3.0 DESIGN OF STRUCTURES, COMPONENTS, EQUIPMENT, AND SYSTEMS

Section 3.1 of the Turkey Point Units 6 and 7 Combined License (COL) Final Safety Analysis Report (FSAR), Revision 8, incorporates by reference Section 3.1, "Conformance with NRC General Design Criteria," of Revision 19 of the AP1000 Design Control Document (DCD).

Figure 3-1 Comparison of applicant's horizontal FIRS with staff FIRS
Also shown are AP1000 CSDRS and the RG 1.60 spectrum anchored at 0.1g.

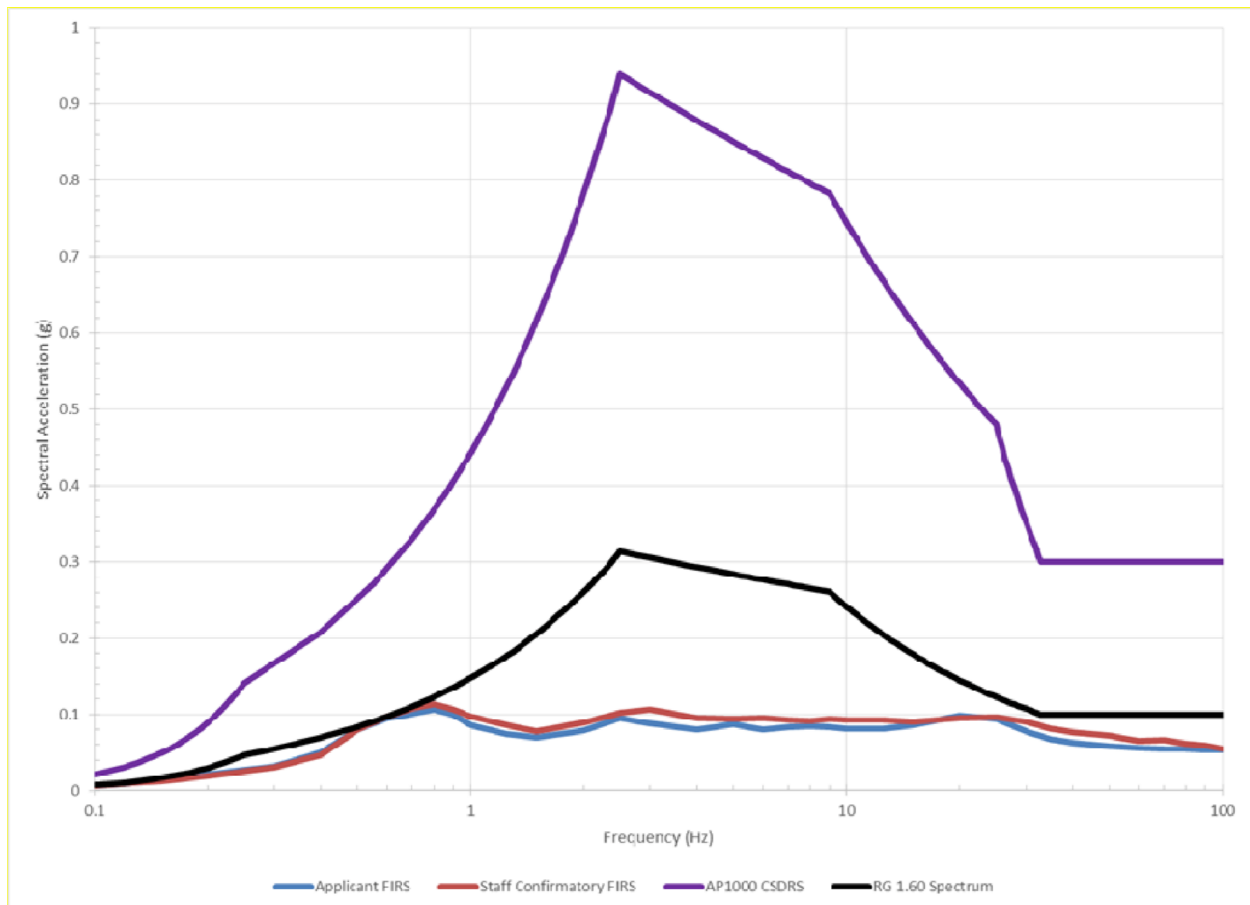
The staff used only the site profile developed for the NI along with the same input response spectra used by the applicant. The staff used only the profile for the NI because the site response for NI structures can reasonably be expected to be consistent with the geologic profile located under the structures. However, the staff notes that the applicant's use of a NI and a FAR profile is conservative because the applicant considers the envelope of the two FIRS results to be the site FIRS. The applicant compared the FIRS at the base of the NI and at the AP1000 CSDRS at plant grade in Figure 3.7-202. The CSDRS for the AP1000 certified design is specified at plant grade. The staff notes that the horizontal design response spectra (DRS) at the surface (which is the same as the performance-based surface response spectrum (PBSRS) defined in ISG-017) shown in Figures 2.1-9 through 2.1-14 of Letter L-2015-085, Attachment 2, dated April 2, 2015, are significantly lower than the CSDRS which is also applied at the surface.

Figure 3-1 compares the applicant's FIRS result with that calculated by the staff, the AP1000 certified design response spectra, and the RG 1.60 response spectra anchored at 0.1g Turkey Point site-specific ground motion applied at the FIRS elevation in the SSI analyses. Overall, the FIRS results are similar, with minor differences attributable to differences in approach and randomization parameters.

The vertical FIRS is obtained by scaling the horizontal FIRS by vertical to horizontal (V/H) ratios from RG 1.60. The horizontal and vertical FIRS were compared to the AP1000 CSDRS and show that the CSDRS envelopes the FIRS. In RAI 4975, Question 03.07.01-12, the staff asked why V/H ratios selected were from RG 1.60 as opposed to V/H ratios from the generic database for the characteristic events associated with the site-specific PSHA.

In its review of SSE motions, the staff indicated in RAI 6432, Question 03.07.01-15, that the response spectra at the foundation level have zero period acceleration values less than the 0.1g required at the foundation depth by Appendix S to 10 CFR Part 50 and Sections 3.0 and 5.4 of DC/COL-ISG-017. The staff requested the applicant to provide a discussion as to how the results meet the requirements for minimum seismic input at the foundation level.

The applicant provided a response on April 2, 2015, which addresses the required minimum seismic input. The applicant stated that the horizontal and vertical SSE motions incorporate a scaling of the motion that is sufficient to achieve at least 0.1g horizontal peak ground acceleration at the bottom of the NI basemat required by Appendix S to 10 CFR Part 50 and

DC/COL-ISG-017. The applicant provided revised site-specific design response spectra at the foundation level comprised of the envelope of the Turkey Point site-specific FIRS and the amplified RG 1.60 spectra scaled to 0.1g to develop the SSE motion meeting the minimum seismic input. Acceleration time histories were matched to the DRS described above and were used in the SSI analysis. The applicant compared the site-specific floor response spectra (FRS) to the envelopes of the AP1000 FRS computed from the CSDRS and hard rock high-frequency (HRHF) at each of the six key NI locations in Section 6.0 of Appendix KK. The site-specific FRS are enveloped by the enveloped FRS from the AP1000 CSDRS and HRHF FRS at each of the six key NI locations.

The staff evaluated the response and found that the use of the amplified RG 1.60 spectra scaled to 0.1g addressed the minimum seismic input in accordance with 10 CFR Part 50, Appendix S, and DC/COL-ISG-017. This motion meets the minimum required seismic input and envelopes the site-specific FIRS.
